**Submission by Civic Trust Auckland on:**

**Organisation:** Civic Trust Auckland

**Submission on Heard Park Concept Plan**

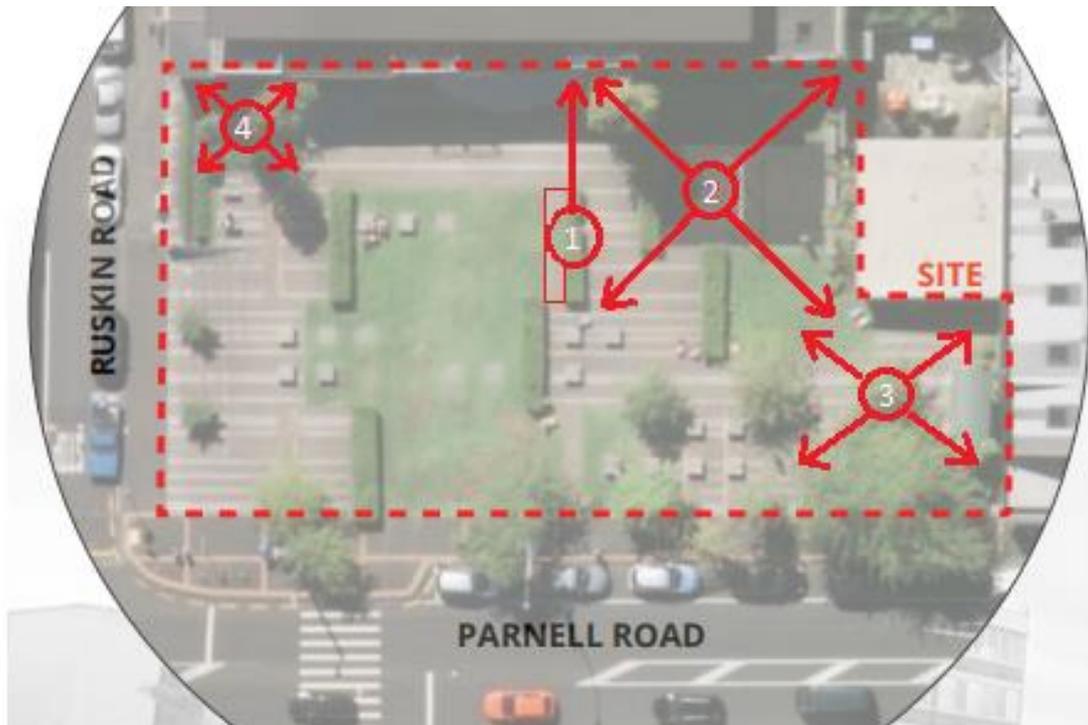
## Seating:

- We do not consider the existing seating unattractive nor particularly uncomfortable. The wooden seating surfaces are certainly warmer to sit on than the concrete and they have aged and blend well with the concrete aesthetic. We also note the success of temporary seating put out during summertime.
